Contract Identification Number : 2023-04-069
Name of Contract : Procurement and Implementation of K-12 Program (MITHI- ICT INFRASTRUCTURE) Negotiated Procurement-Two Failed Biddings
Location of the Contract/Project : Cogon, Dipolog City

Supplemental/Bid Bulletin

Addendum No. 1

Proposed Fiber Cabling Plan for the Indoor Fiber Cable for the Administration Building

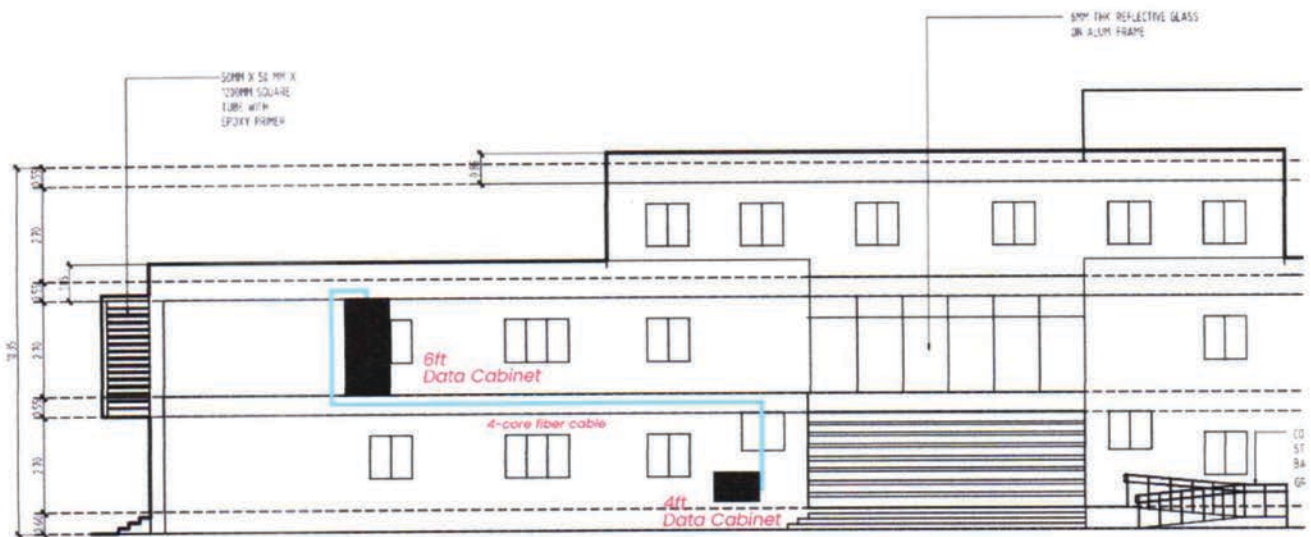
- A conduit must surround the 4-Core Fiber Optic Cable.
- With PSHS-ZRC's approval, the contractor may propose or create a plan for the fiber cable that connects Administration Building Ground Floor to 2nd Floor
